## CITY OF WACONIA PLANNING COMMISSION AGENDA

<b>Meeting Date:</b>	April 7 <sup>th</sup> , 2016
<b>Item Name:</b>	SITE PLAN and DESIGN REVIEW: Request by Jack Fiedler and Laura Menser for a proposed dental office for the property located at 732 Vista Blvd.
<b>Originating Department:</b>	Planning and Zoning
<b>Presented by:</b>	Angie Perera, Assistant Planner

**Provide recommendation to City Council regarding Site Plan and Design Review for a proposed dental office for the property located at 732 Vista Blvd.**

## TITLE SHEET, NOTES & LEGEND

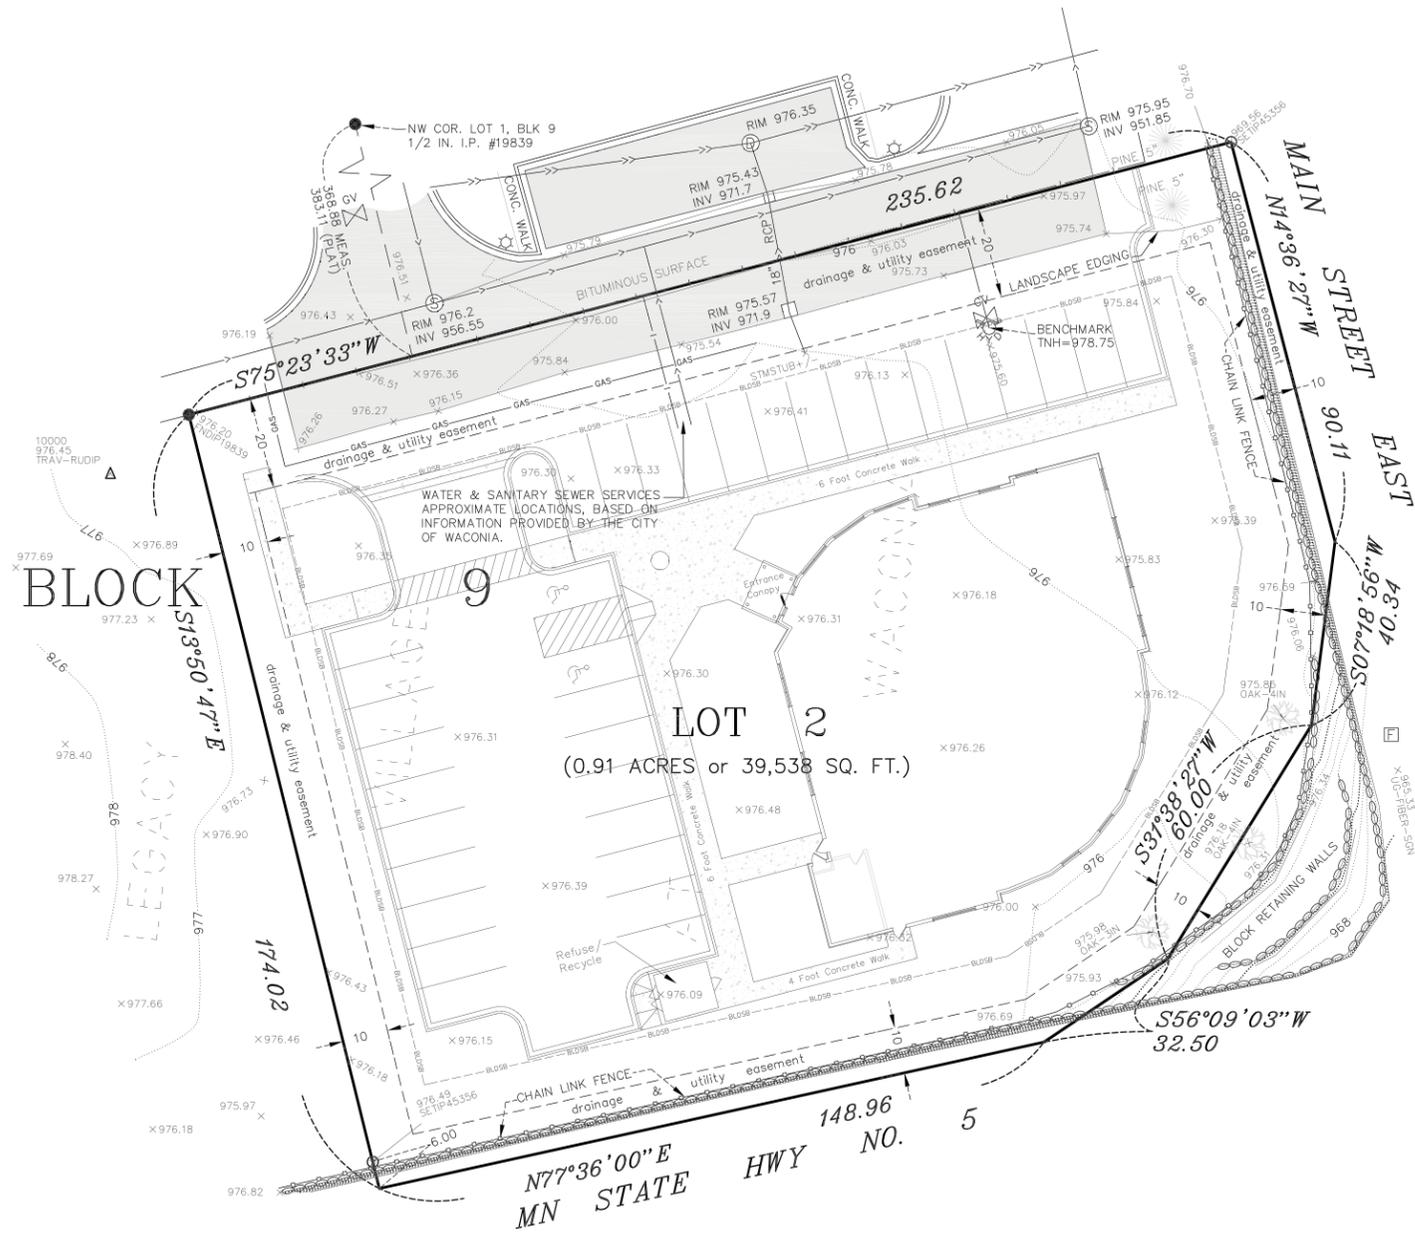
City Comments: The building setback line “BLDSB” appears to be indicated on sheet C1 of the Site Plan however the actual proposed setbacks of the building and the trash enclosure should be noted on the actual plans (ie. Trash enclosure: south lot line: 22 ft., north lot line: XX ft., west lot line: XX ft., east lot line: XX ft. and Building: south lot line: 30 ft., north lot line: XX ft., west lot line: XX ft., east lot line: XX ft.)

**LANDSCAPE PLAN**  
**FIEDLER, D.D.S.**

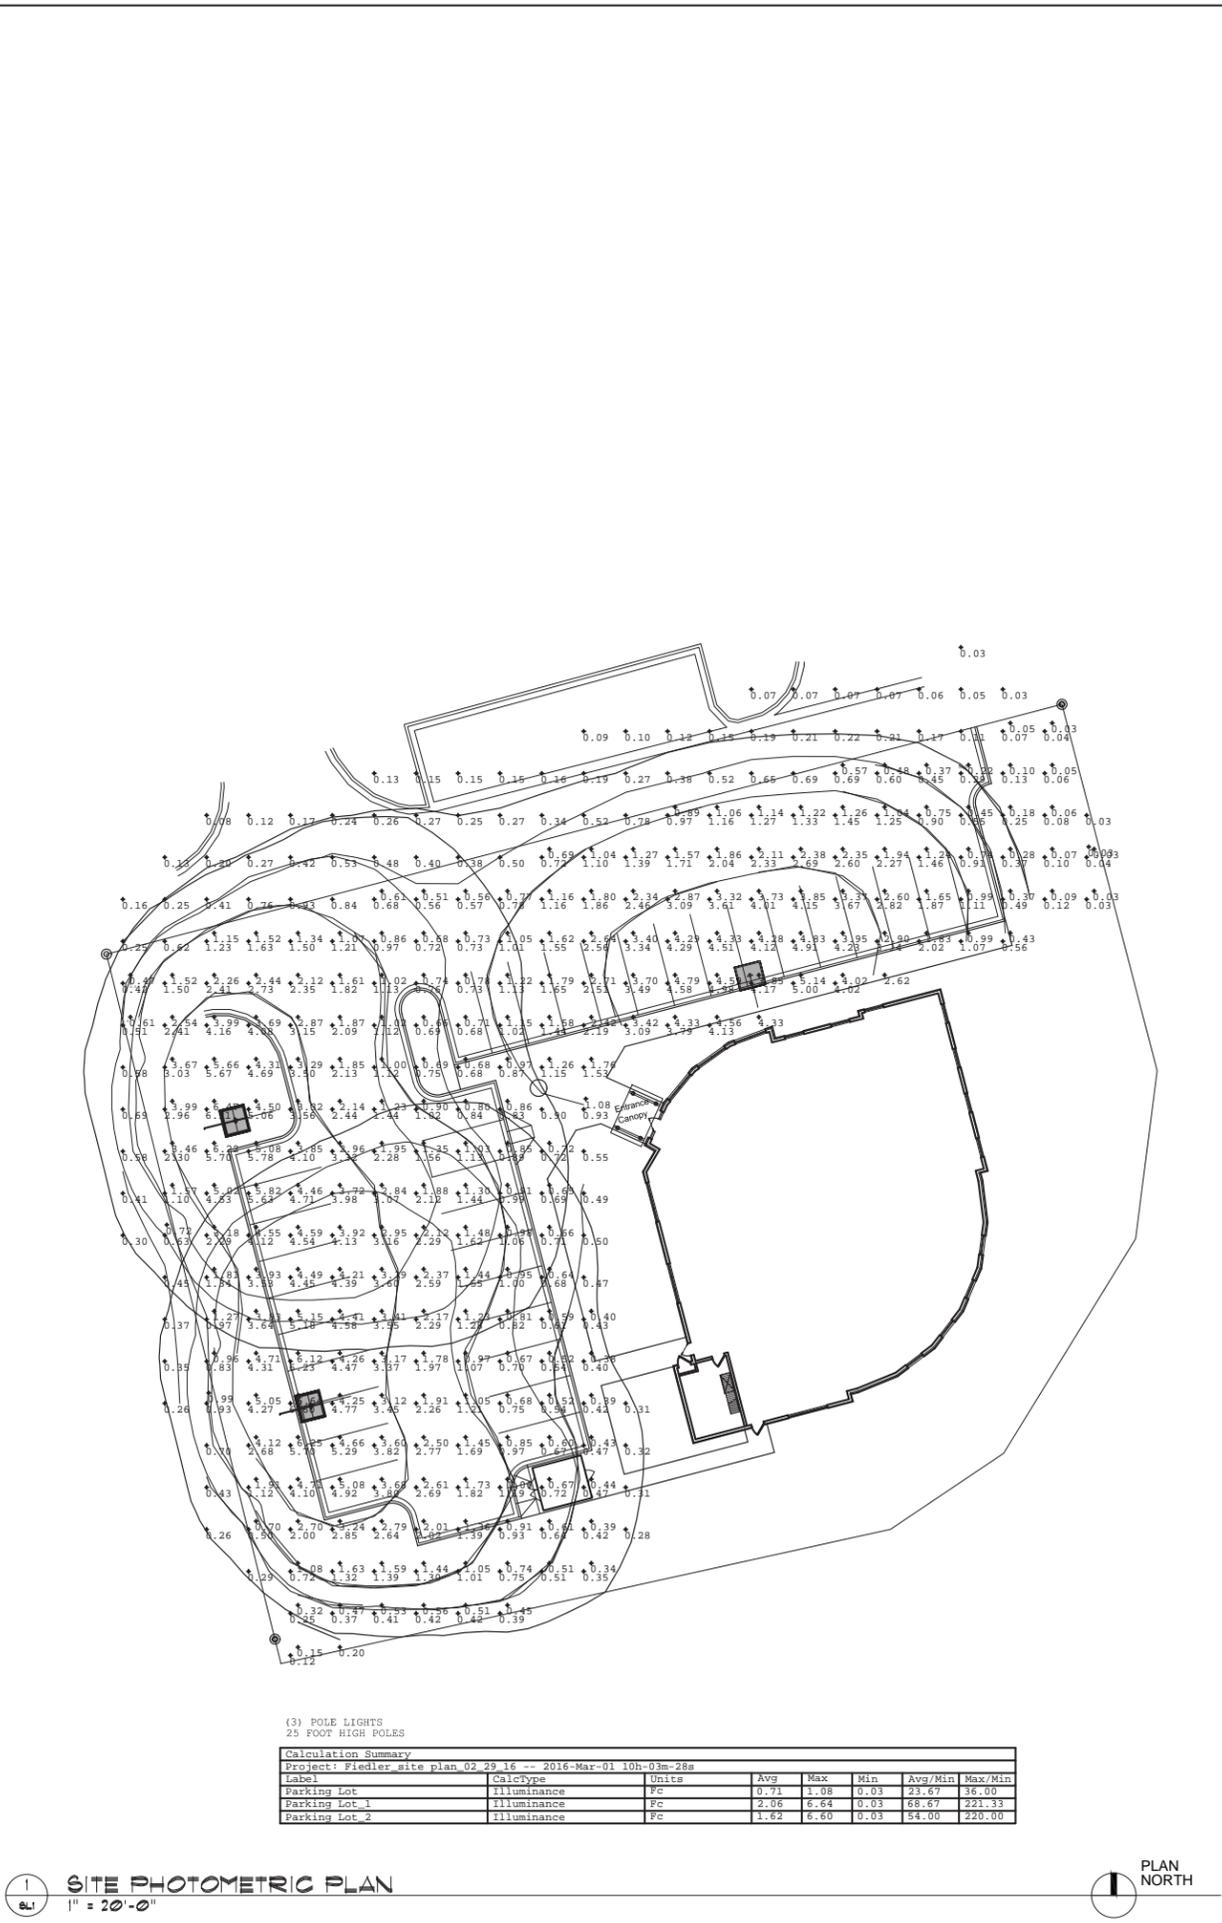
*Staff would like to make note that the legend on the aforementioned landscape plans (sheet L1) is not consistent with the label noted for the one, 3” Swamp White Oak tree that is proposed in the southwest corner of the property. Staff would recommend a condition of Site Plan approval, that at least one of the proposed trees meet the 3” caliper inch requirement (for one of the deciduous trees) or else one of the proposed trees will meet the 8’ height requirement (for one coniferous tree).*

6. The legend on the aforementioned landscape plans (sheet L1) is not consistent with the label noted for the one, 3" Swamp White Oak tree that is proposed in the southwest corner of the property and therefore at least one of the proposed trees will meet the 3" caliper inch requirement (for one of the deciduous trees) or else one of the proposed trees will meet the 8' height requirement (for one coniferous tree).

9. It appears that the three existing trees in the SE corner of the site are proposed to be removed on sheet C1 but not noted as such on the landscape plan on sheet L1 – please update the landscape plan to reflect the proposed removal of these three trees if they are intended to be removed. Also, if the other exiting tree in the NE corner of the site is intended to be replanted elsewhere onsite, the proposed location shall be included on the landscape plans.

CD  
A2.0

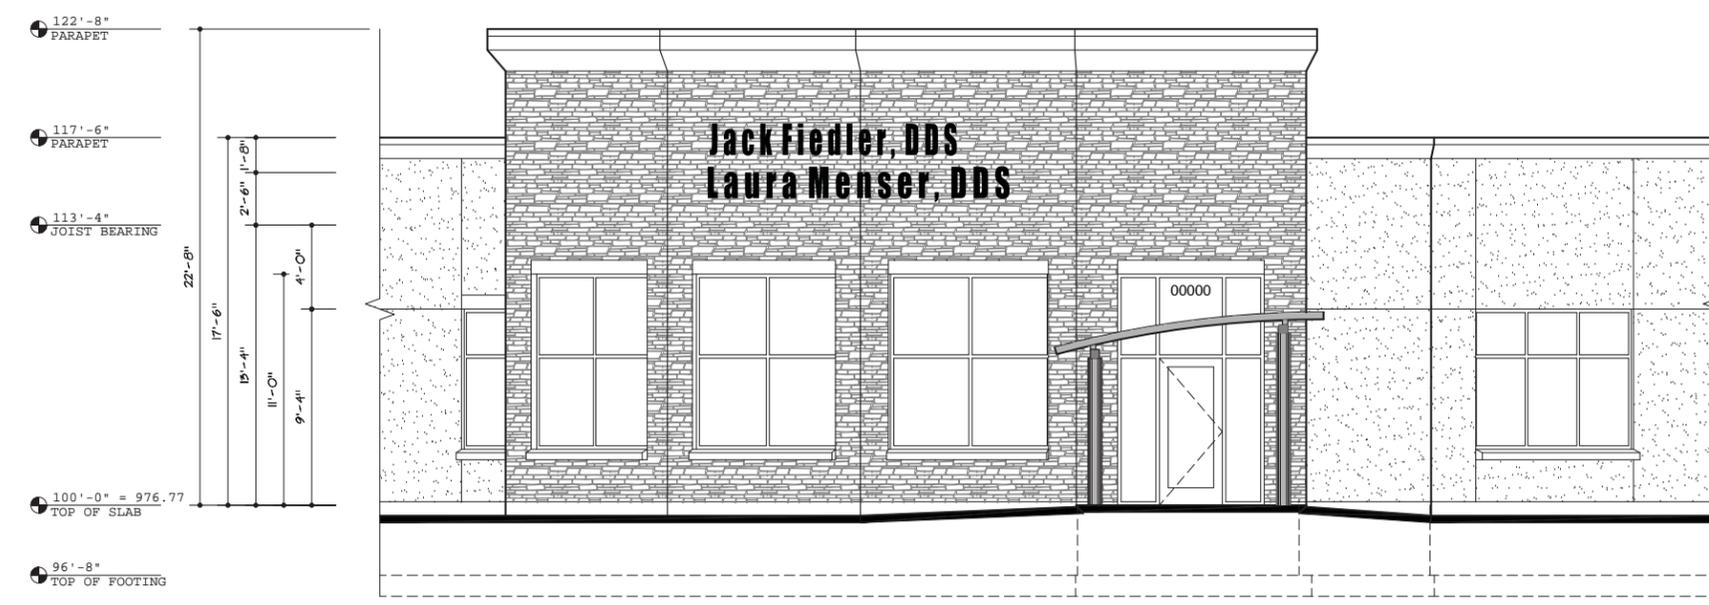
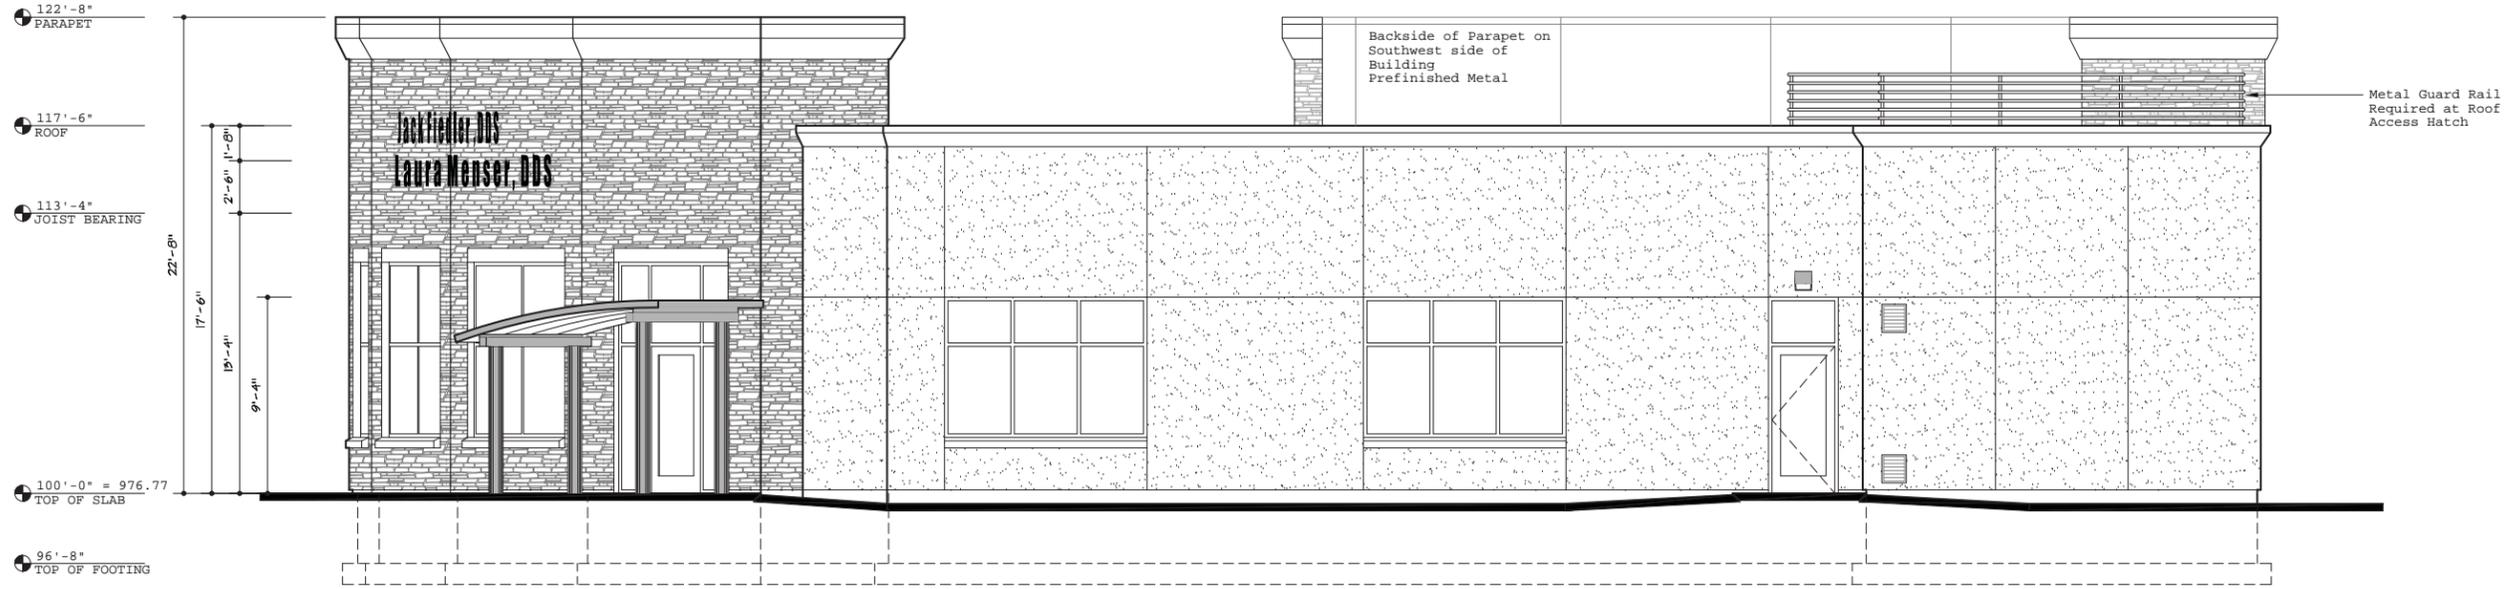
**Design Response:** *The proposed building materials are in compliance with the Highway District Design Standards. The Exterior Material & Finish Schedule will include EIFS and manufactured stone veneer. The proposed colors are noted as "to be selected" on sheet A2.0 of the Site Plan submittal documents. The applicant*
